# INSTALLATION MANUAL

REF NO.	BA03007
DATE	Feb. 18, 2003

**SUBJECT:** INTRODUCTION OF HYDRAULIC PIPING CLAMP

**PURPOSE:** To introduce modification procedure to improve the hydraulic piping clamping clips

Fig

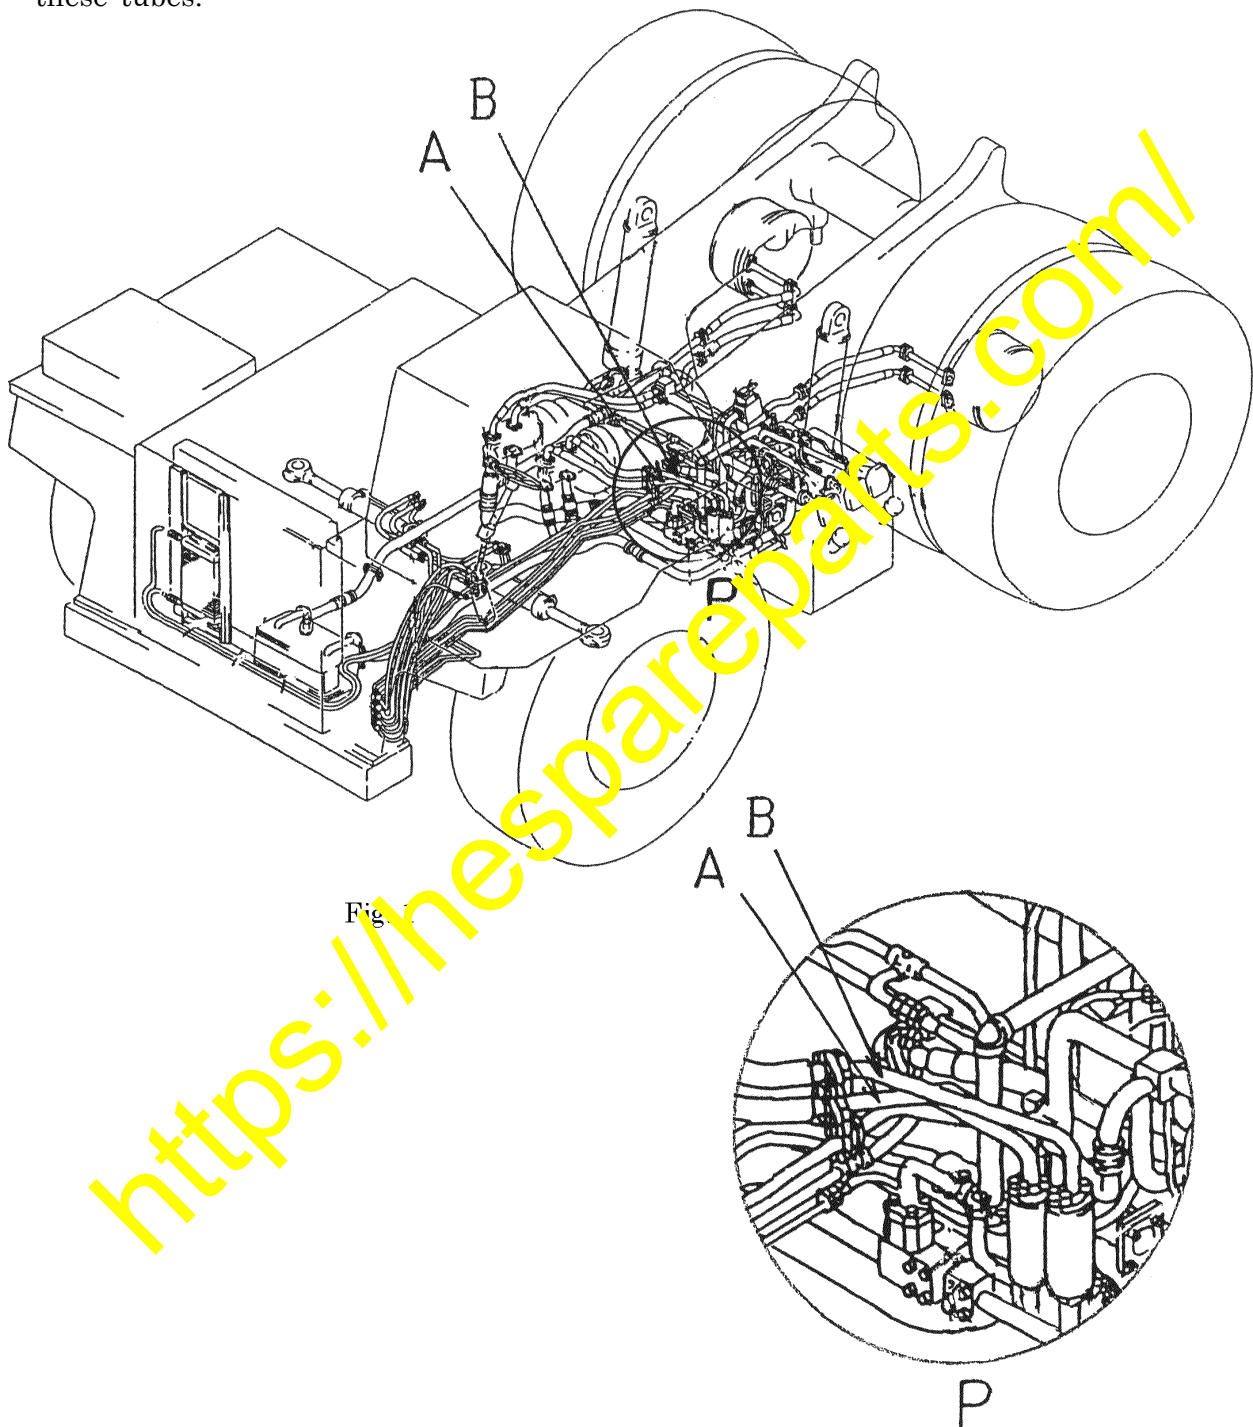
With the already shipped dump trucks the hydraulic piping clamping clips may become loose because of hydraulic vibrations of the steering line tube and the hoist oil line tube, resulting in possible cracking of the tubes.

Since it is possible to keep the hydraulic piping clamping clips from becoming loose by changing the hydraulic piping clamping clips to the type to use the seat, this **INSTALLATION MANUAL** will introduce the modification procedure to make the change

Change the clips which are clamping the tubes connecting between the pump and the line filter of the steering line and of the hoisting line onto the bracket to the clips of the type to use the seat which are less apt to become loose even when substantial hydraulic vibrations are applied to the tubes, in order to prevent occurrence of cracks in these tubes.

Fig. 2 ( In case of HD785 )

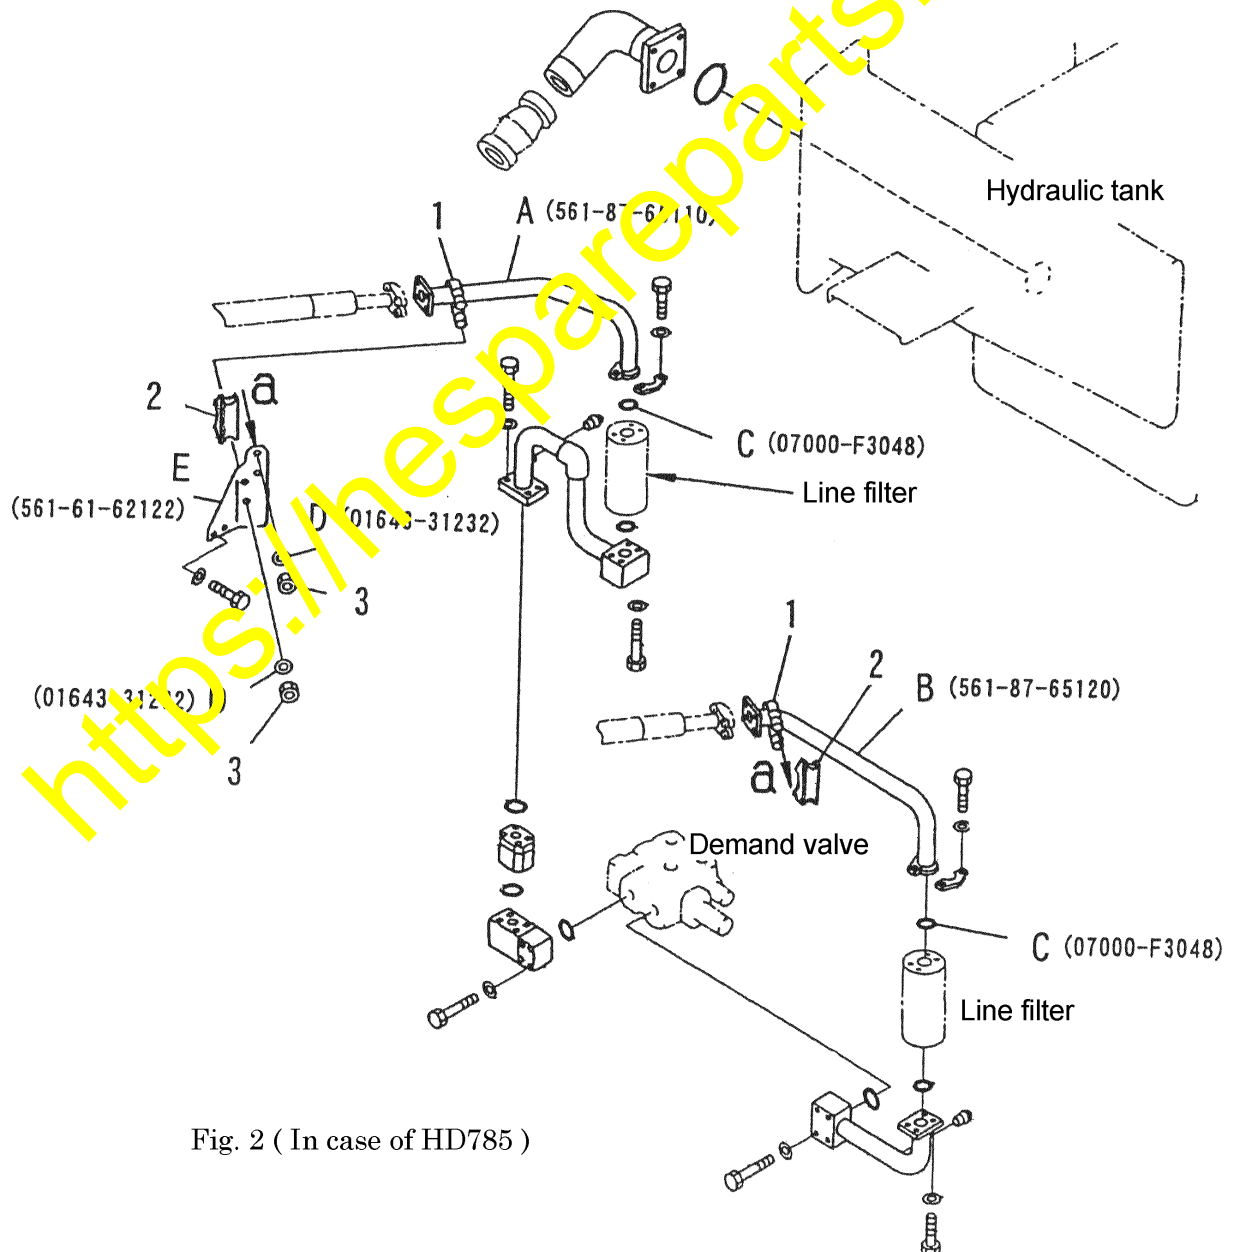
In case of HD785, refer to Fig. 2 and in case of HD985, refer to Fig. 3.

- (1) Remove the clip (1), washer (D) and nut (3) which are clamping the tube connecting between the pump and the line filter to the bracket. Abolish the removed clip (1) and the nut (3).
- (2) Inserting the seat (2) between the bracket (E) and the tube (A or B), clamp the tube using the newly prepared clip (1) and nut (3) and the removed washer (D).
- (3) If the tube (A or B) is cracked, replace the tube (A or B) together with the O-ring (C) to new parts.
- (4) If the tube is pressed forcefully while being clamped by the thickness of the additional seat (2), remove the bracket (E) and make the additional working (to change the round hole to a slotted hole) as per Fig. 4.

In the meantime, when reinstalling the bracket (E), adjust the positioning of the bracket (E) so as not to make gaps between the contact surfaces of the seat (2) for the tube (A or B) and the bracket (E).
